Access Compliance Report

Public Rights-of-Way

(Curb Ramps)

Intersection ID: 21797	Main Street: GALLERIA_BV	Cross Street: MONROE_RD	Location: SW
ADA ID: 35B1778CF3D0	Ramp Type: Perp	Initial Pass/Fail: Fail	Overall Compliance: No
Codes/Mitigation Info/Possible Solution		Field Measurements/Component Compliance	
Severity Score: 13.75

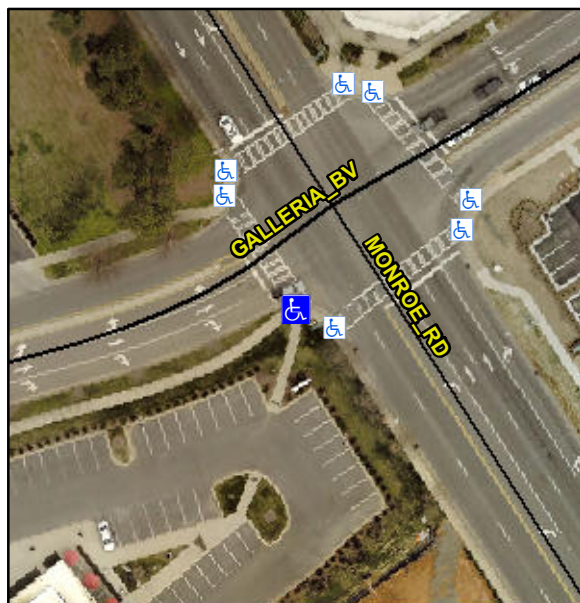
Not Found, R304.2.2

Compliance	Description	Data	Compliance	Description	Data
N/A	Ramp Length (in)	26.0	No	Ramp Slope (%)	8.7
Yes	Ramp Width (in)	48.0	Yes	Ramp XSlope (%)	2.3
N/A	Flare Type LT	N/A	N/A	Flare Type RT	N/A
N/A	Flare Slope LT (%)	N/A	N/A	Flare Slope RT (%)	N/A
N/A	Flare Traversable LT?	N/A	N/A	Flare Traversable RT?	N/A
N/A	Landing Length (in)	N/A	N/A	DWS Provided?	N/A
N/A	Landing Width (in)	N/A	N/A	DWS Contrast?	N/A
N/A	Landing Slope (%)	N/A	N/A	DWS Length (in)	N/A
N/A	Landing X Slope (%)	N/A	N/A	DWS Full Width?	N/A
N/A	Landing Curb? (Y/N)	N/A	N/A	DWS Offset (in)	N/A
N/A	Shared Landing?	N/A			
N/A	Gutter Ponding?	N/A	N/A	Gutter Slope (%)	N/A
N/A	Gutter Lip Ht (in)	N/A	N/A	Gutter X Slope (%)	N/A
N/A	Painted X Walk1?	Yes	N/A	Painted X Walk2?	N/A
	X Walk 1 Direction	To NW		X Walk 2 Direction	N/A
N/A	X Walk 1 Width (in)	113.0	N/A	X Walk 2 Width (in)	N/A
	X Walk 1 Slope (%)	0.8		X Walk 2 Slope (%)	N/A
	X Walk 1 X Slope (%)	3.7		X Walk 2 X Slope (%)	N/A

Remove & Replace Entire Ramp.
